ADDENDUM NO. 2
DATE: AUGUST 1, 2007

Project: 7-C-15; Cancer Survivor Park Ditch Improvements

SHEET NO. C-1

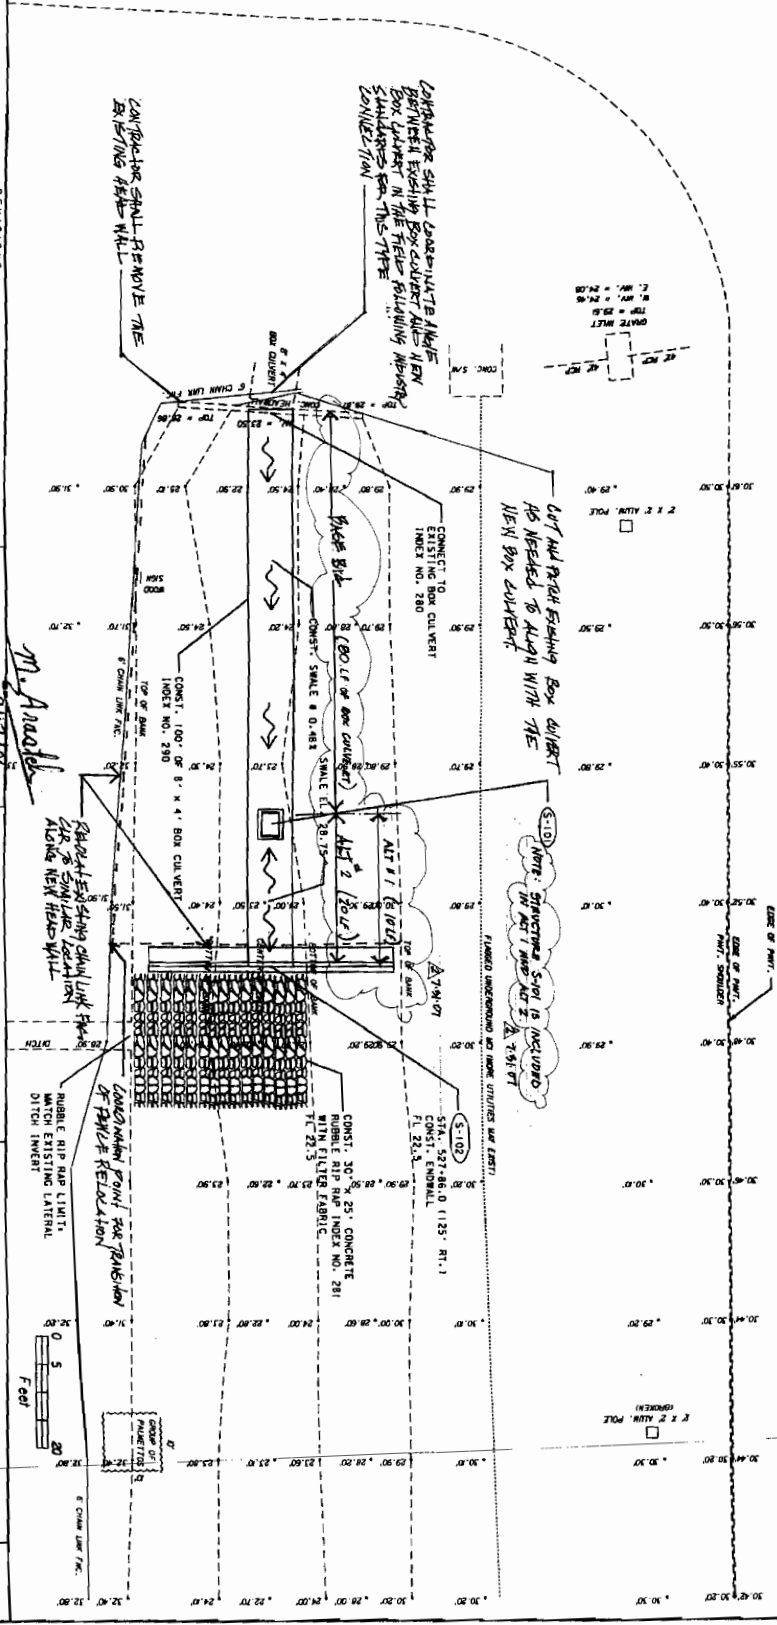
- Item 5: Replace drawing C-1 with the attached C-1, dated July 31, 2007; thereby modifying the base bid length of culvert and Alternates 1 and 2 to match the information provided on proposal sheets P-3 and P-4.
